STATE OF NORTH CAROLINA
DEPARTMENT OF TRANSPORTATION

SUBJECT: Buncombe County, Replace Bridge No.134 over Stony Fork Creek; T.I.P.
Number B-4034; Federal Aid Project No. BRSTP-151(10); State Project
8.1845901

From: Beckwith, Loretta A SAW [Loretta.A.Beckwith@usace.army.mil]
Sent: Monday, November 15, 2010 11:32 AM
To: Lusk, Elizabeth L
Cc: Leamer, Jeremy T; Dagnino, Carla S
Subject: RE: B-4034 messages

PROJECT REFERENCE NO. B-4034	SHEET NO. 4
RAW SHEET NO.	
ROADWAY DESIGN ENGINEER	HYDRAULICS ENGINEER
PRELIMINARY PLANS DO NOT USE FOR CONSTRUCTION

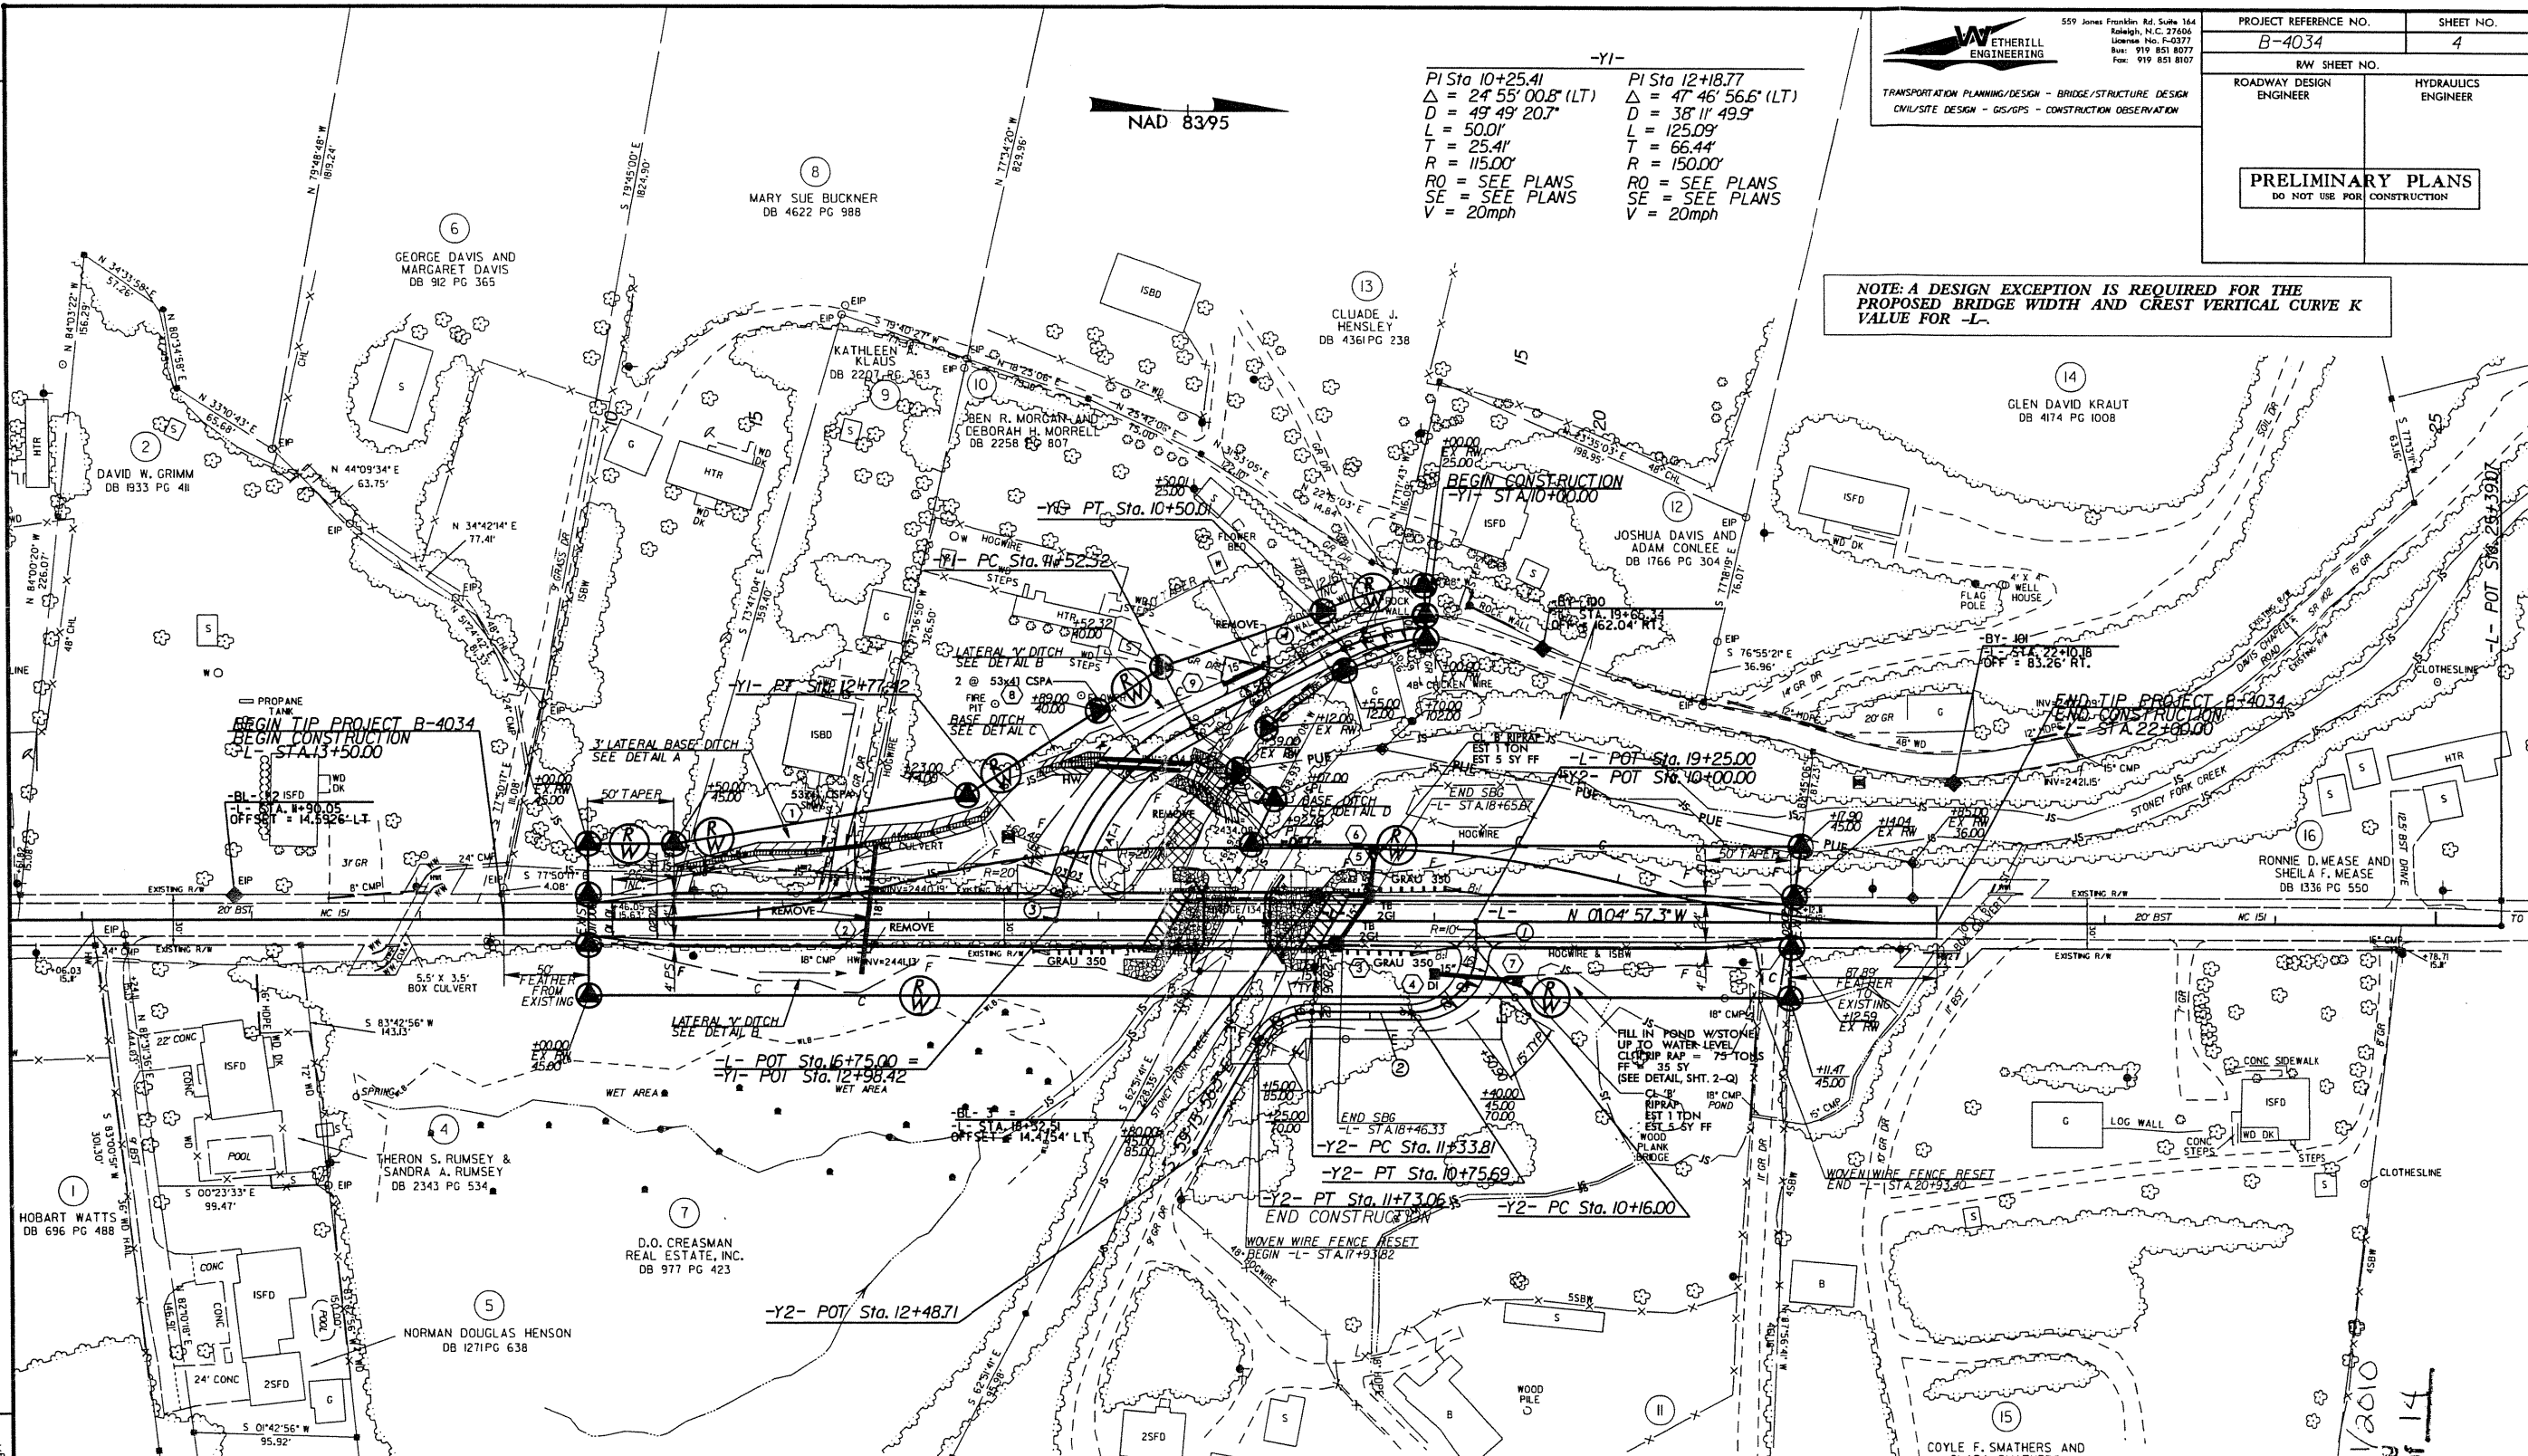
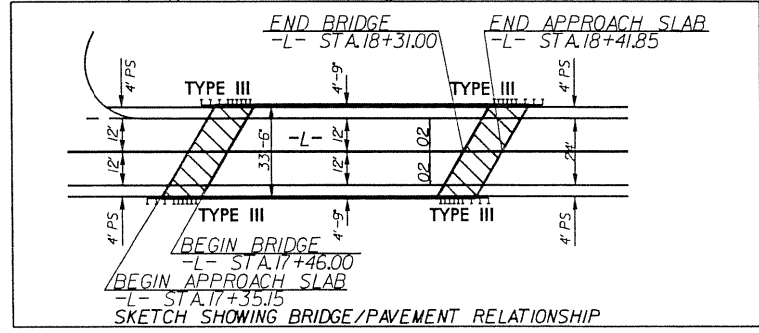
As we discussed last week, in order to comply with a requirement from Land Quality, you will add rip rap (class B stone) to the newly relocated channel (UT to Stony Fork Creek). All rip rap will be flush with the bottom base of the new channel.

After review of the plans (attached to this e-mail) and comments from WRC, we have determined that the addition of 375' of rip rap, if installed so that it is flush with the bottom of the new channel, is reasonable. As such, you are authorized to place the rip rap along 375' of new channel. No additional mitigation is required.

Yes, the main crossing has not changed from our application. There will be a spanning structure over Stony Fork Creek. Please note that there is no new fill in Waters of the U.S. and, as Carla noted, the invert of the rip rap will be the base of the new channel, i.e. the rip rap will be "keyed into" the channel, not merely sitting on the bottom.

At the risk of sending you something you've already been sent, I'm attaching the revised plan sheet. I believe the only change was to Detail A at the bottom of the sheet.

In addition to ensuring that the rip rap is flush with the bottom of the new channel, the project must be conducted in compliance with all conditions of the original verification letter of October 15, 2009.
